RE: **PETITION NO. 1323** - Windham Solar LLC declaratory ruling that no Certificate of Environmental Compatibility and Public Need is required for the proposed construction, maintenance and operation of three 2.0 Megawatt AC and two 1.0 Megawatt AC solar photovoltaic electric generating facilities on an approximate 43 acre parcel located at 134 Bilton Road, Somers, Connecticut. **Development and Management Plan.**

Petition No. 1323

Development & Management Plan

Staff Report

Site Plan

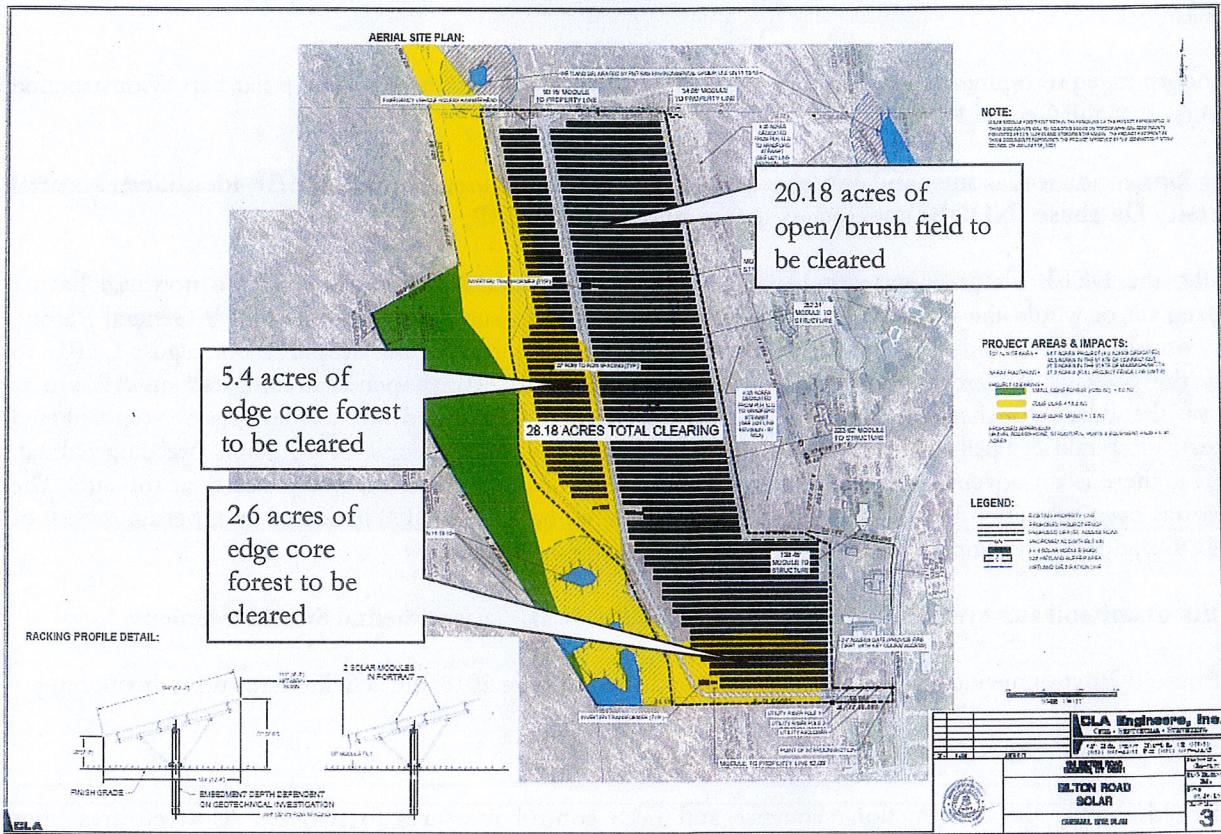
Approximately 28.2 acres of total clearing is required to accommodate the 27.3 acre fenced solar array area. See attached figure titled Site Plan.
